Well Name: POKER LAKE UNIT 20 BD	Well Location: T25S / R30E / SEC 20 / SWSE / 32.108598 / -103.901003	County or Parish/State: EDDY / NM
Well Number: 310H	Type of Well: OIL WELL	Allottee or Tribe Name:
Lease Number: NMLC064894	Unit or CA Name: POKER LAKE UNIT	Unit or CA Number: NMNM71016X
US Well Number:	Operator: XTO PERMIAN OPERATING LLC

Sundry ID: 2844293

Type of Action: APD Change

XTO Permian Operating, LLC. respectfully requests approval to make the following changes to the approved APD. Changes to include KOP, FTP, LTP, BHL, proposed total depth, and pool.

ACREAGE DEDICATION PLATS

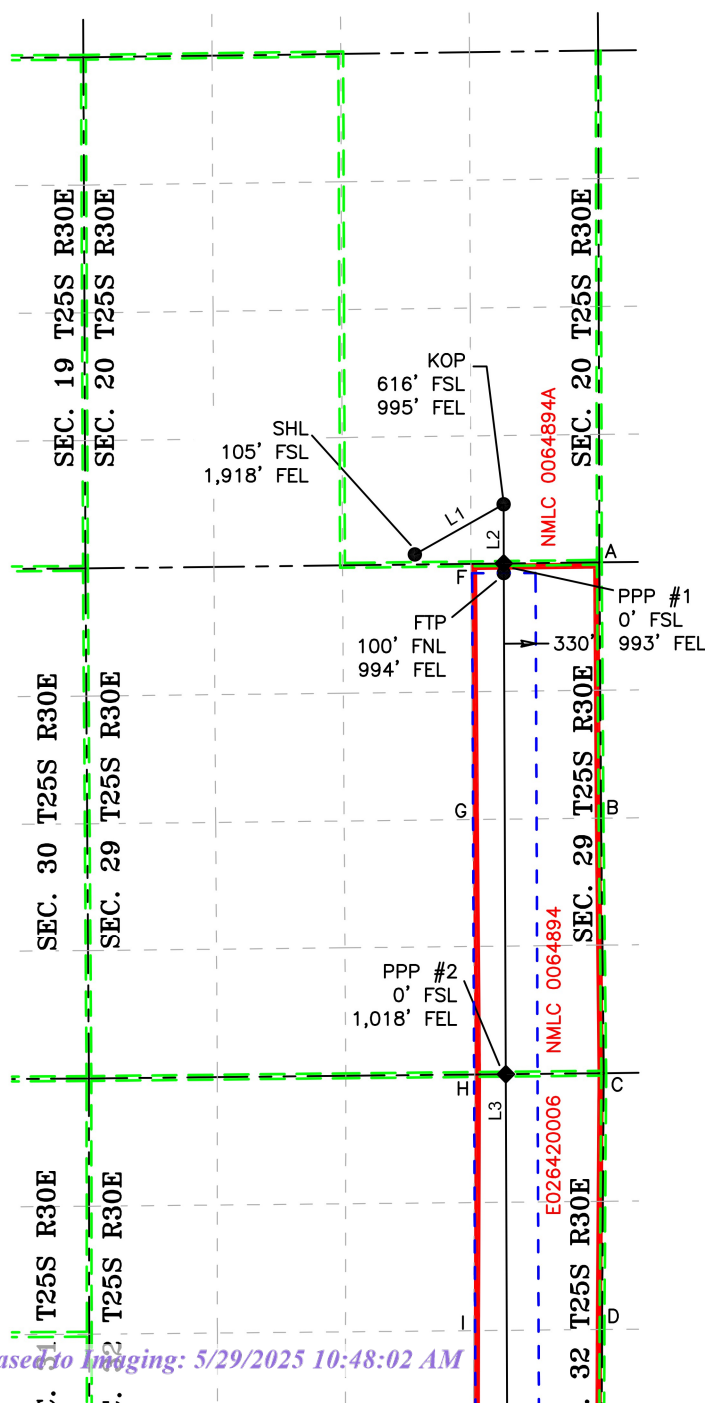
KOP: 105 FSL & 1918 FEL OF SECTION 20-T25S-R30E 616 FSL & 995 FEL OF SECTION 20-T25S-R30E
FTP: 100' FNL & 1525' FEL OF SECTION 29-T25S-R30E 100' FNL & 994' FEL OF SECTION 29-T25S-R30E
LTP: 100' FSL & 1525' FEL OF SECTION 32-T25S-R30E 100' FSL & 971' FEL OF SECTION 32-T25S-R30E
BHL: 50' FSL & 1525' FEL OF SECTION 32-T25S-R30E 50' FSL & 970' FEL OF SECTION 32-T25S-R30E

The proposed total depth is changing from 20165 MD; 9330 TVD to 20519 MD; 9494 TVD.
